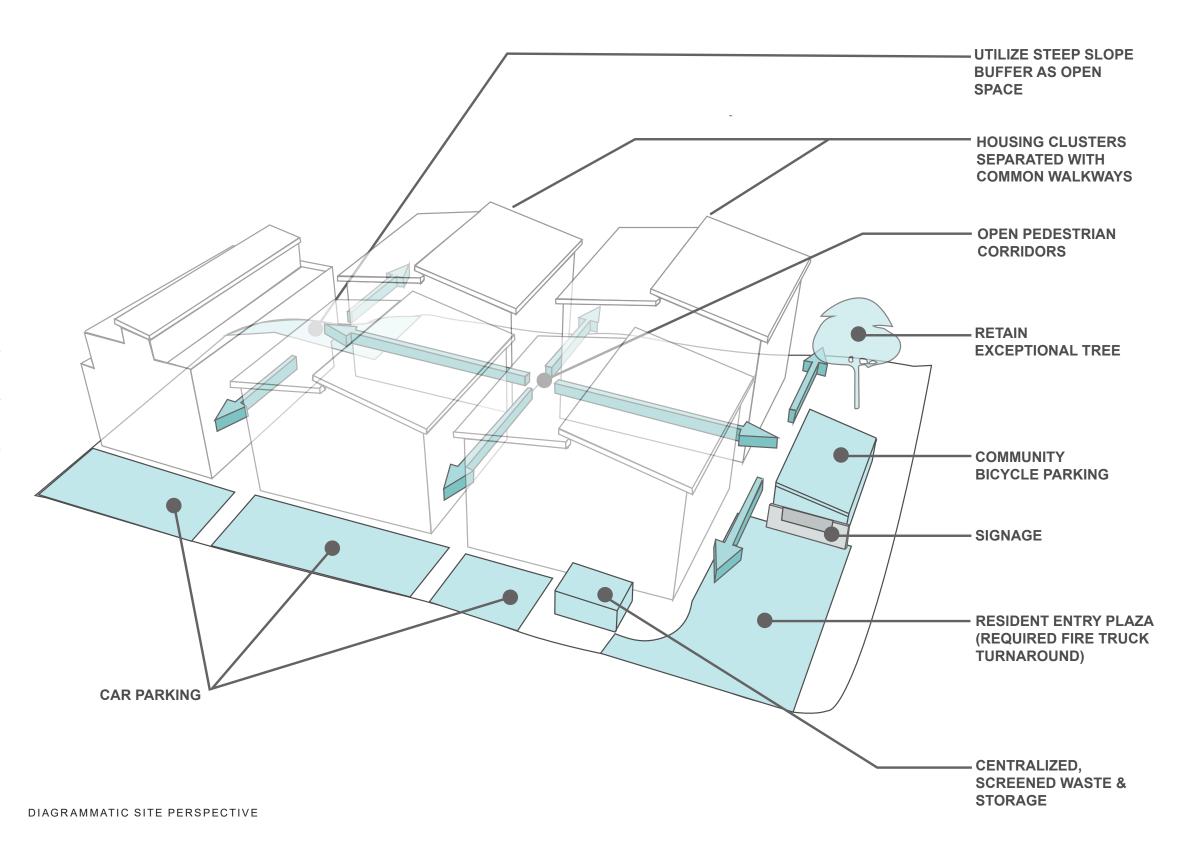
2. SITE PLANNING AND PUBLIC REALM:

a. Staff supports the site concept which bundles the townhouse structures in small clusters, allowing for pedestrian pathways, light, air, and open space on all four sides of the buildings. The placement of the buildings is further influenced by the steep slope erosion area at the northwest corner and the exceptional tree at the northwest corner, both of which are to be preserved. Lastly, services such as the trash and recycle storage area, bicycle parking, and vehicular parking are located for equal access and ease of use for all units. The site concept as outlined and illustrated is supported (Option Three, page 18 of the EDG packet). CS1-B, CS1-D, PL1-B, PL4-II

The site plan proposed has been maintained. Buildings are bundled to allow for pedestrian pathways, air, light, and space on all four sides of each building. The steep slope and exceptional tree have been undisturbed. We have thoughtfully designed the spaces around these natural features to enhance the residents experience. Bicycle parking, vehicular parking, and trash and recycling storage area have remained on the south east corner of the property for ease of access for public services and to all residents.

PERSPECTIVE OF STEEP SLOPE PROGRAM INTEGRATION

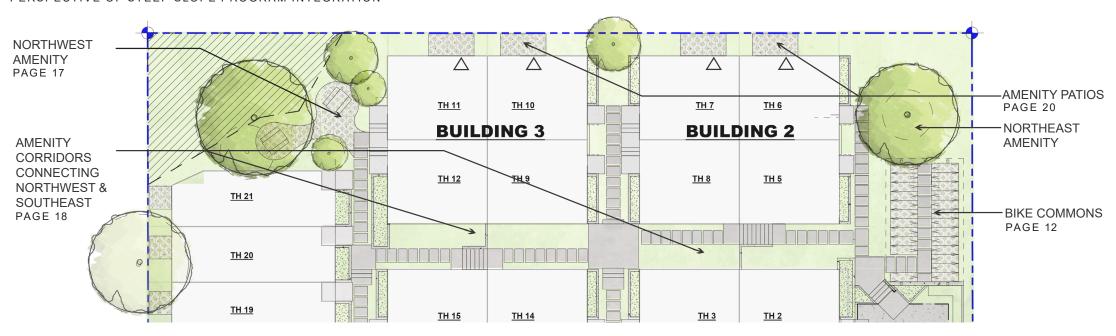
c. The siting of the buildings to preserve the existing steep slope and exceptional tree at the northwest and northeast corners of the site. DC2-A, DC3-I, CS1-C, CS1-D, CS1-III-iii

- b. Staff supports the retention of the existing Exceptional Tree, Pacific Madrone, which is located near the northeast corner of the site. Include on the plan set all appropriate tree protection requirements. CS1-D
- c. The preservation of the existing steep slope and exceptional tree is supported; however, there is some concern regarding usable amenity space for the townhouse units without a rooftop deck. Please develop this element to encourage its use by residents and show clearly (with some combination of plan, section, elevation, perspective) how this solution meets the criteria in DC3-A, DC3-B, and DC3-I.

The two existing natural features of the site: the steep slope in the north west corner and the exceptional tree in the north east corner, have been preserved and thoughtfully developed to provide pleasant amenity spaces.

The steep slope's natural vegetation has been retained, and the surrounding area has been preserved as an open space. Landscaping and seating have been sensitively integrated to create a common amenity space alongside the existing habitat for all residents to enjoy.

The Pacific madrone at the north east corner of the site has been undisturbed in the existing rockery. The exceptional tree is incorporated into Townhouse 6's private amenity space, providing a calm, shaded, and natural entry to the residents.

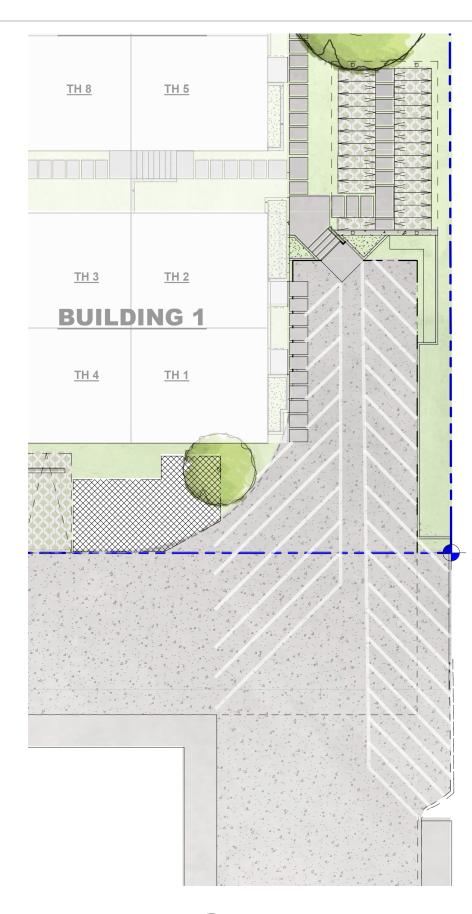
d. The placement of the trash and recycle storage area along the south property line, adjacent the vehicular parking, and away from abutting residential development to mitigate odor and pest concerns. DC1-C

d. The site receives vehicular and pedestrian access from 29th Ave S, which ends approximately 20-feet south of the subject site. Please describe how this intermediary space is treated currently and any plans for improvements. DC1-C, DC1-III

The trash and recycling storage area has been placed along the south perimeter of the property for the convenience of public services. Because of the proximity to the townhouses, the trash enclosure has been carefully designed with screening and vegetation to provide a buffer for the residents.

The vehicular and pedestrian access from 29th Ave S has been sized to meet fire truck turnaround requirements but is recognized as an important transition threshold for pedestrians. We propose that this space can serve a duel function and act as a community plaza for residents. Multiple uses have been integrated including pedestrian circulation, children's play space, property signage location, and outdoor gathering space.

A painted surface is proposed to transition from where the sidewalk ends at the end of 29th ave S to our property line. The painted pattern is intended to slow cars as well as guide pedestrians safely to the site.
